YELLOW CREEK NUCLEAR PLANT UNITS 1 AND 2 - COMBUSTION ENGINEERING FAILURE
TO IMPLEMENT DESIGN CRITERIA - YCRD-50-566/81-12, YCRD-50-567/81-10 -
FIRST INTERIM REPORT

ENCLOSURE
YELLOW CREEK NUCLEAR PLANT UNITS 1 AND 2
COMBUSTION ENGINEERING: FAILURE TO IMPLEMENT
DESIGN CRITERIA
YCRD-50-566/81-12, YCRD-50-567/81-10
10 CFR 50.55(e)
FIRST INTERIM REPORT

FIGURE 1: Spent Fuel Pool Embedment
(Original Design, Typical) NTS

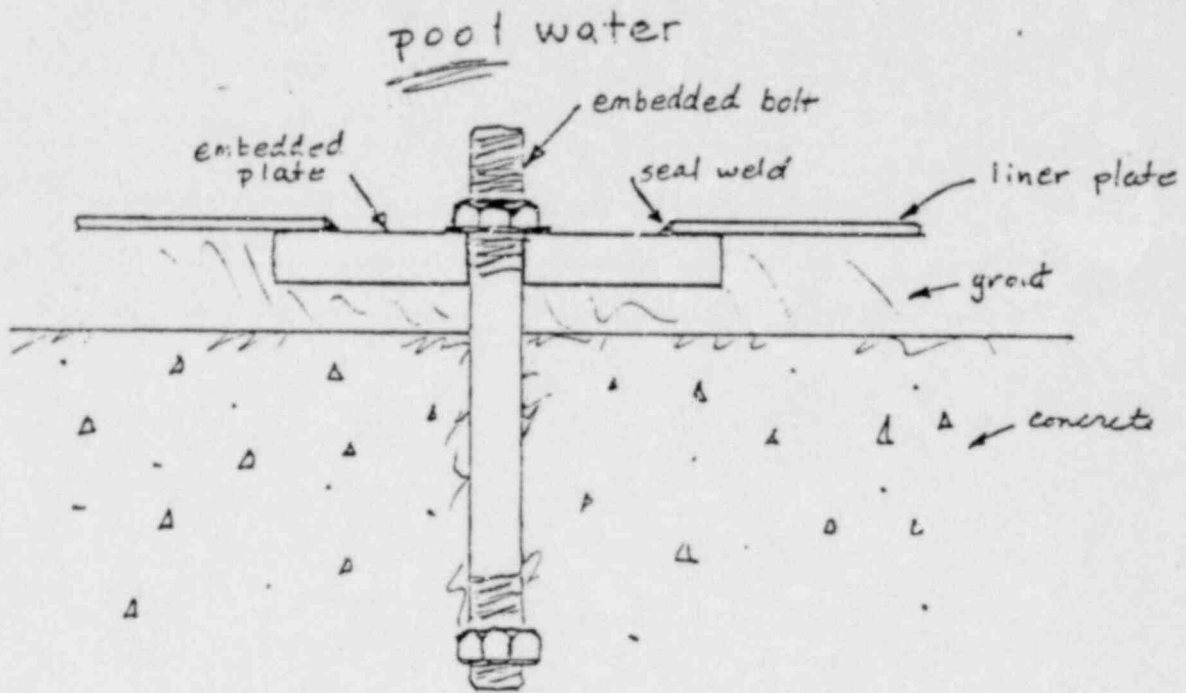
While construction employees at the site were preparing to install the spent fuel rack embedment anchor bolts, they discovered that Combustion Engineering's (CE's) design would not adequately prevent leakage of spent fuel pool water past the embedment anchor bolt nut and washer because the design does not allow seal welding to the anchor bolt (see figure 1). The potential leakage path presented by the embedment design violates the NRC Regulatory Guide (RG) 1.13 recommendations, of which CE is cognizant. TVA design criteria are also violated in that if leakage were to occur, no means are available for early detection and quantification of the leakage other than by a lowering in the pool level. TVA's review should have determined the violation of TVA design criteria since CE is not cognizant of requirements specific to TVA design criteria. The spent fuel pool embedments were designed and supplied by CE.

CE and TVA have jointly developed a recommended design to alleviate the deficiency in design of the spent fuel rack embedments. The proposed design calls for countersinking the embedment bolt and nut into the embedded plate and machining the top of the bolt to be flush with or lower than the top surface of the embedded plate, so that the liner plate can be lapped over the bolts and seal welded to the embedded plate (see figure 2). To meet TVA's design criteria for leakage detection, a channel will be machined between the bolt locations and the liner seal weld around the entire embedded plate. This channel will be routed off the side of the plate into the leakage channel system beneath the pool liner. CE is now in the process of revising the design drawings to incorporate the design. The modification to the embedded plates will be completed before installation of the plates.
